**TOWN OF PLYMOUTH
PLYMOUTH MUNICIPAL AIRPORT**

CONSTRUCT, MARK, AND LIGHT TAXIWAY 'E' EXTENSION (APPROX. 500' X 35')

AIP No. 3-25-0042-53-2021

ADDENDUM No. 1

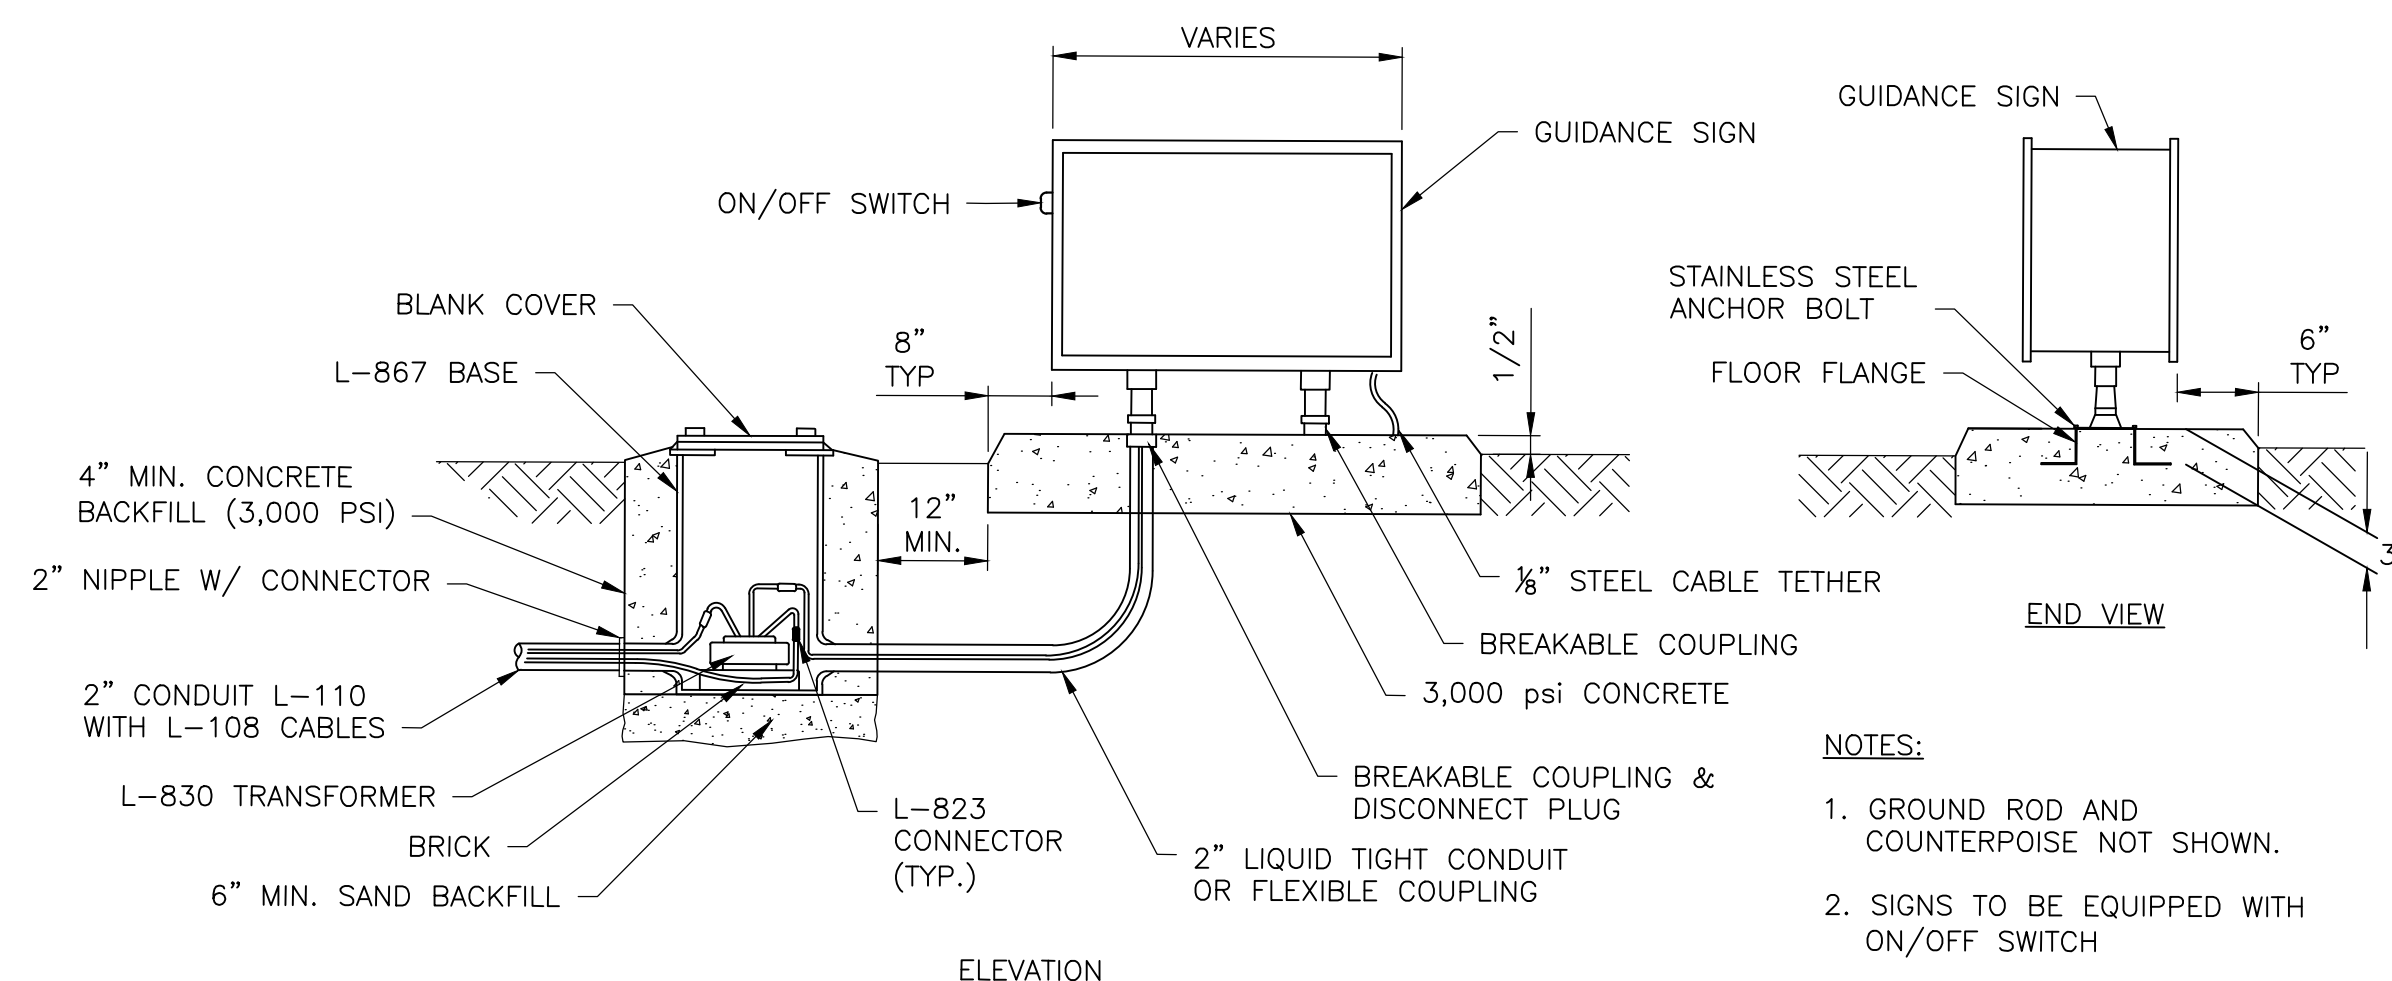
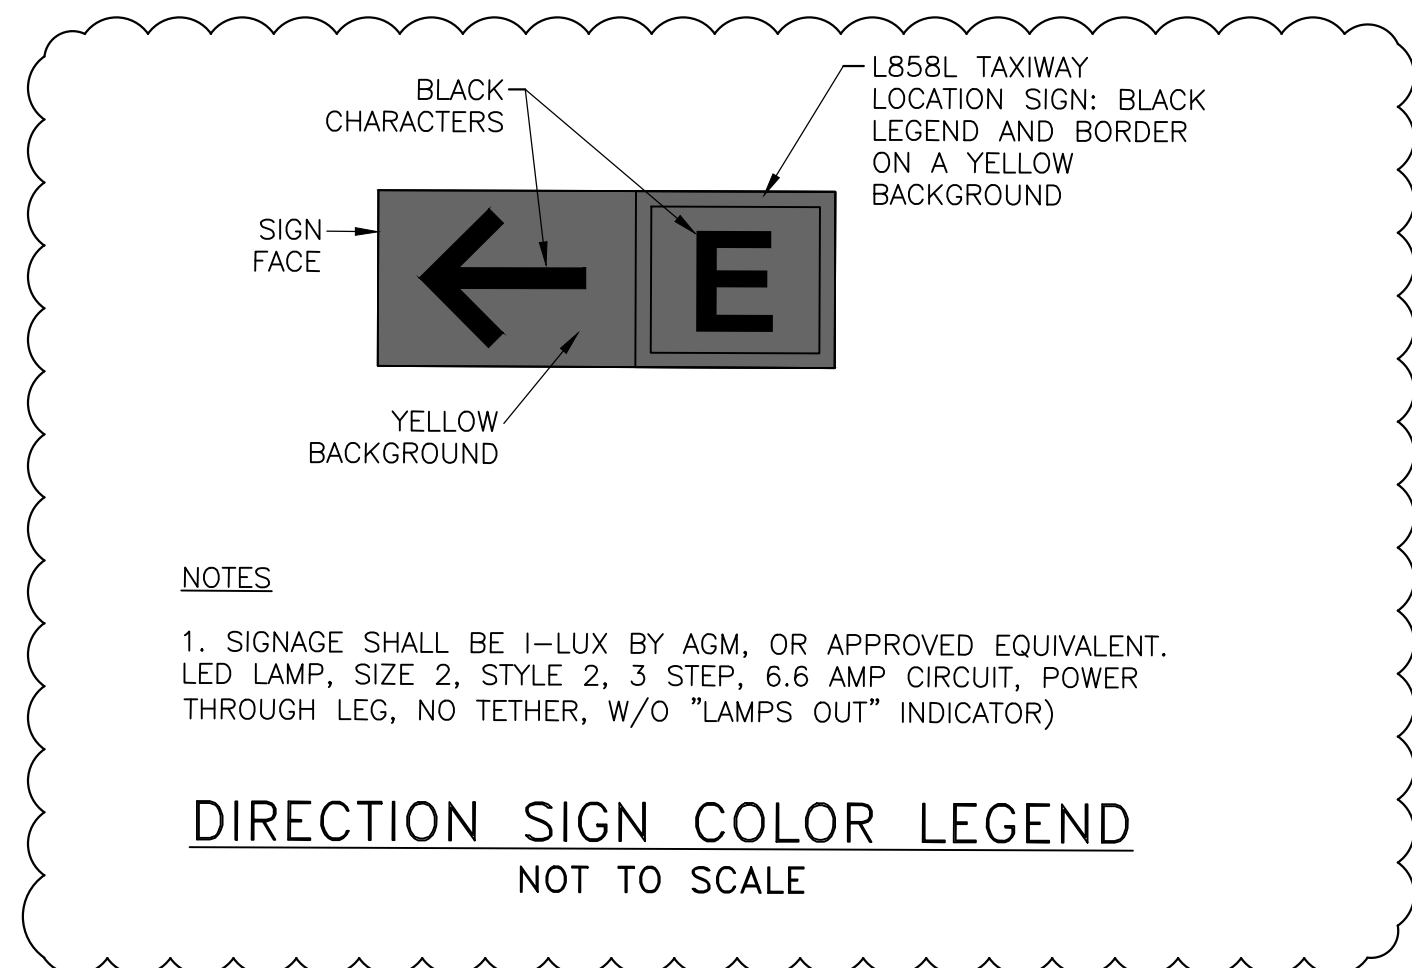
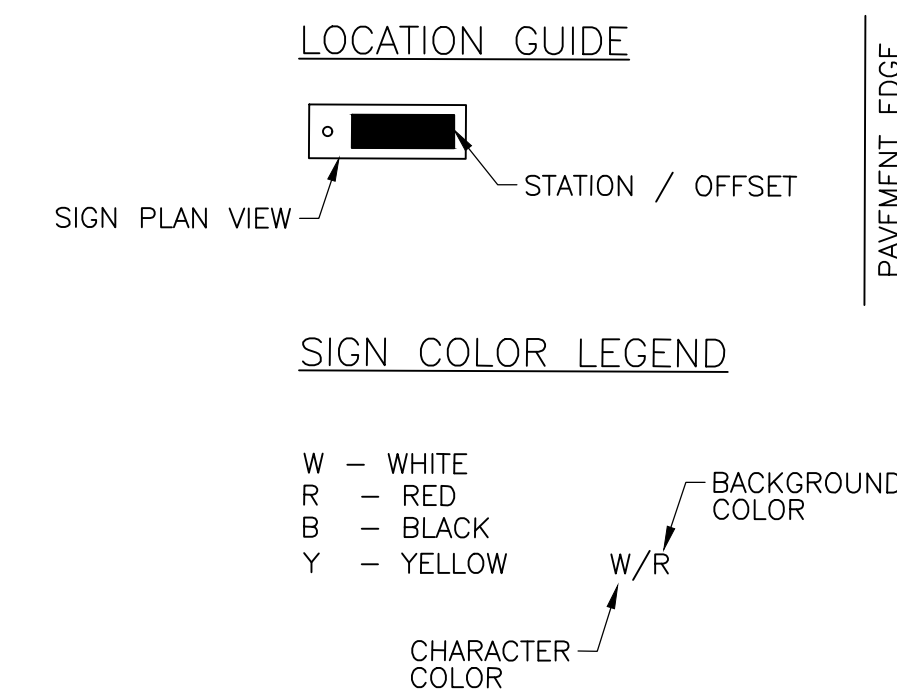
8. Drawing L2.2 has been revised to include two new signs: ILS Hold sign and Noise Abatement sign. Additionally, new direction sign detail has been revised to specify I-LUX by AGM or approved equivalent.

M1.1

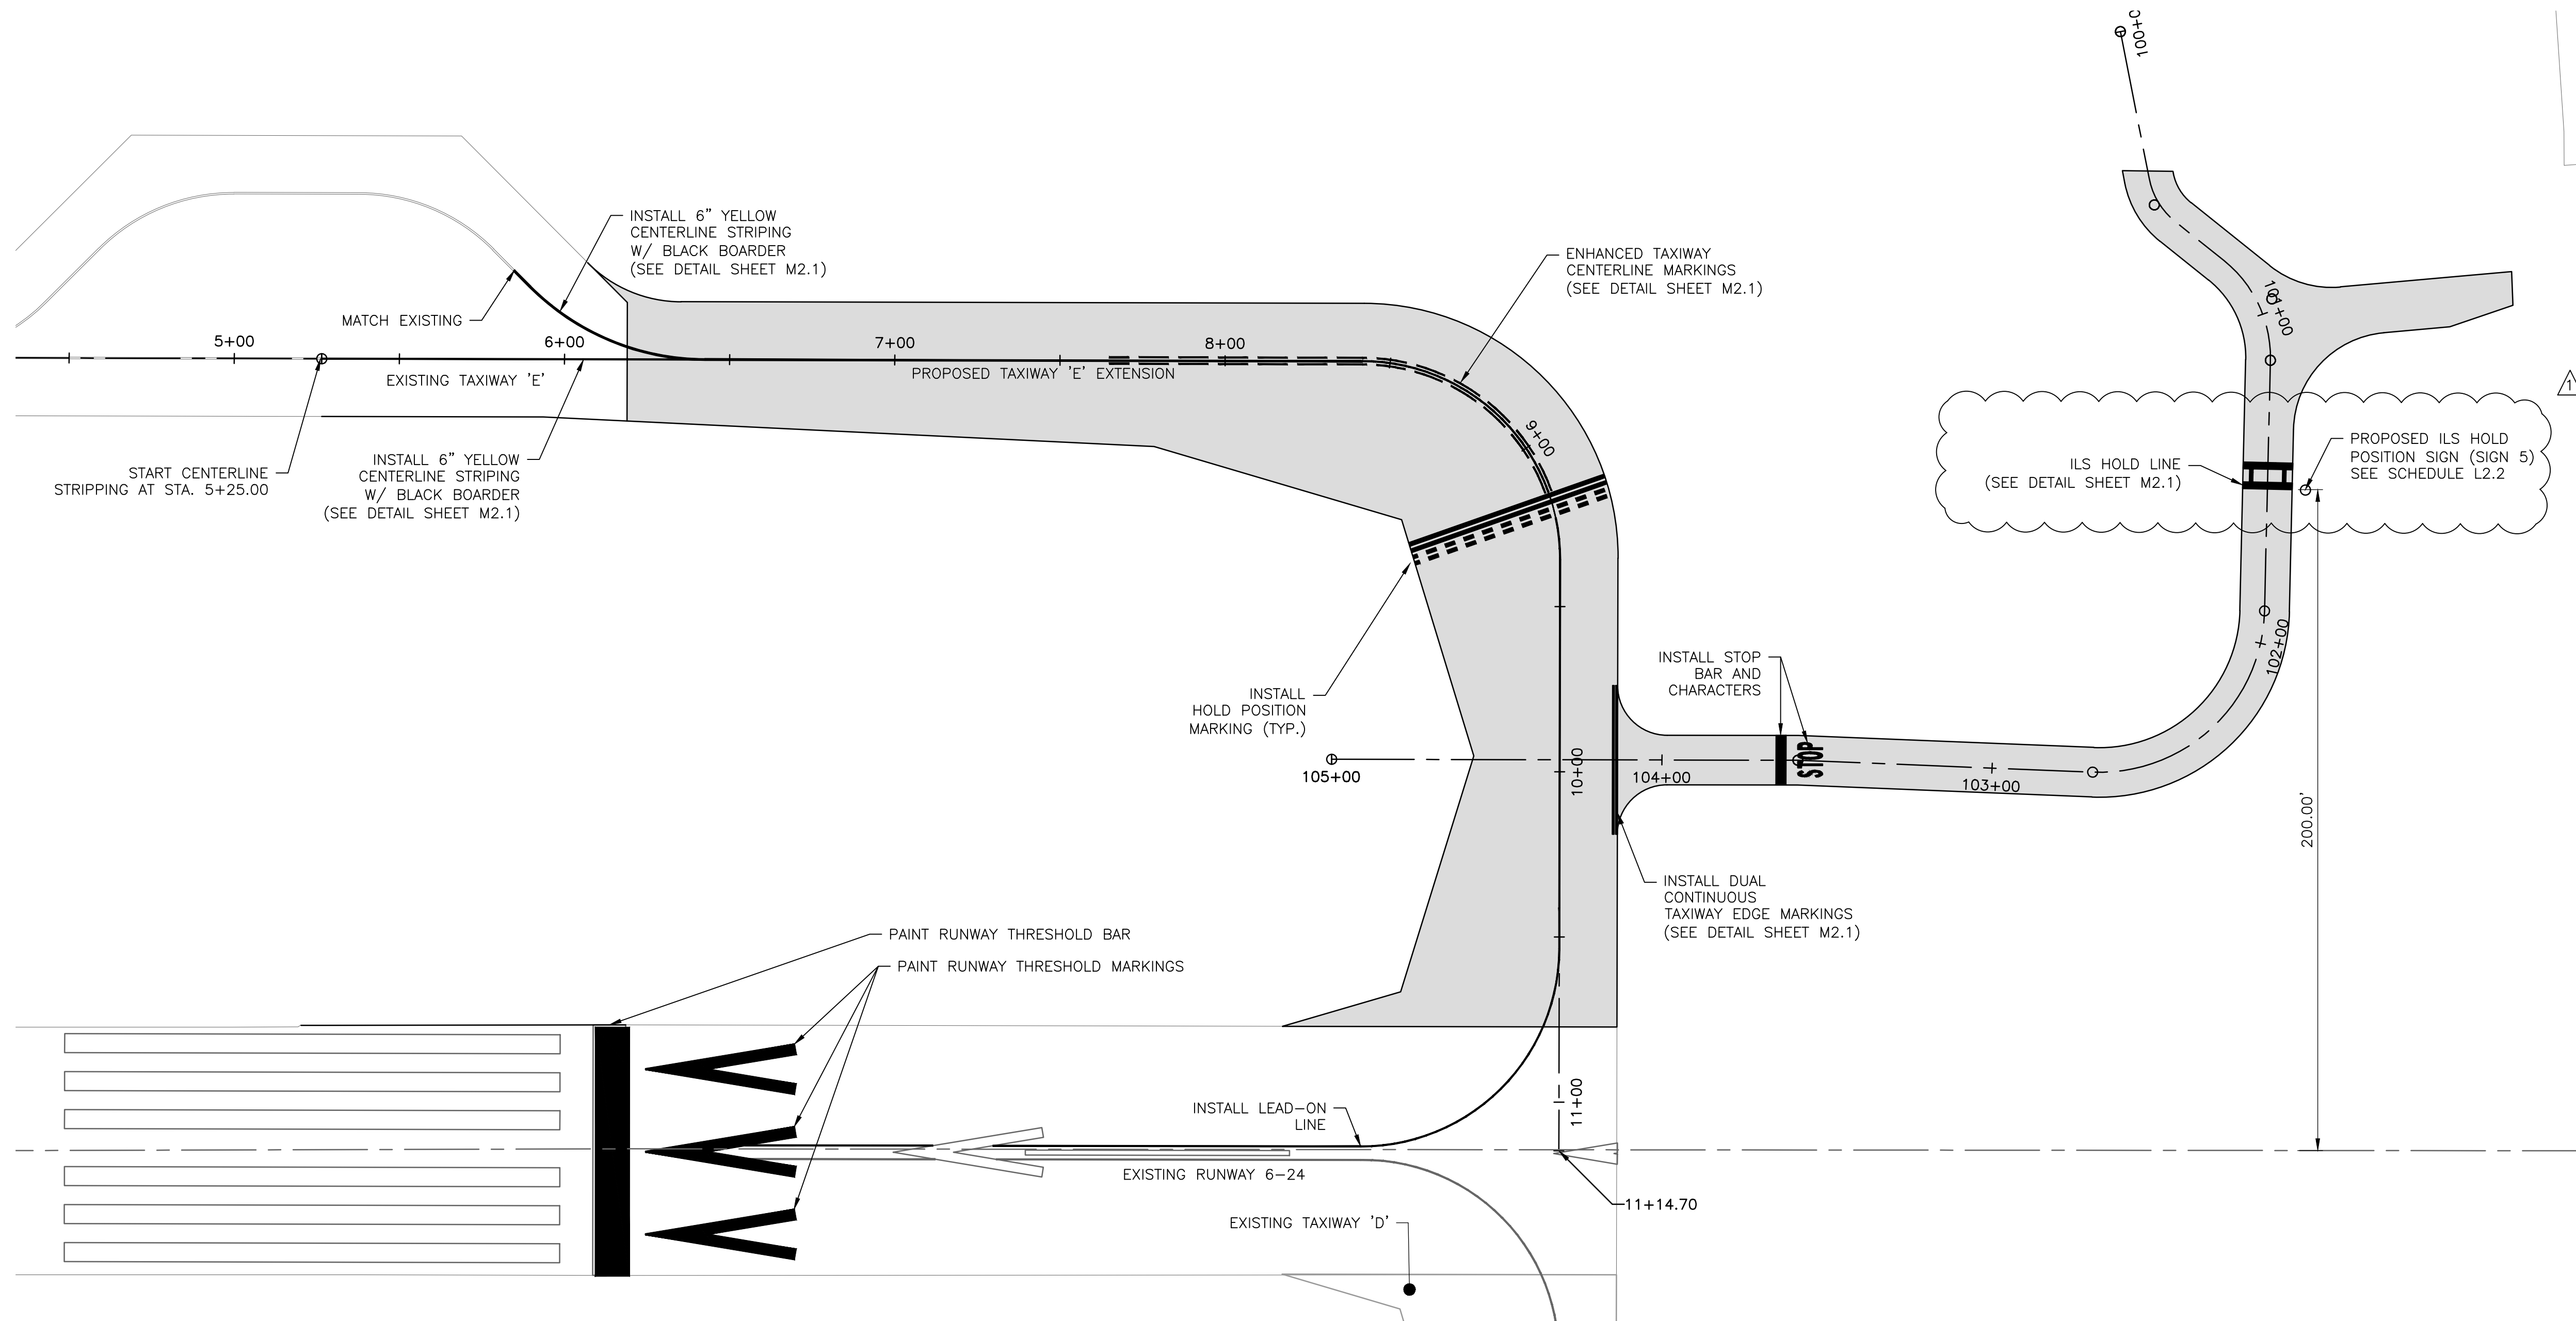
9. Drawing M1.1 has been revised to add additional ILS Hold line and show the location of Sign 5.
10. Drawing M2.1 has been revised to add a detail for the ILS Holding position marking.
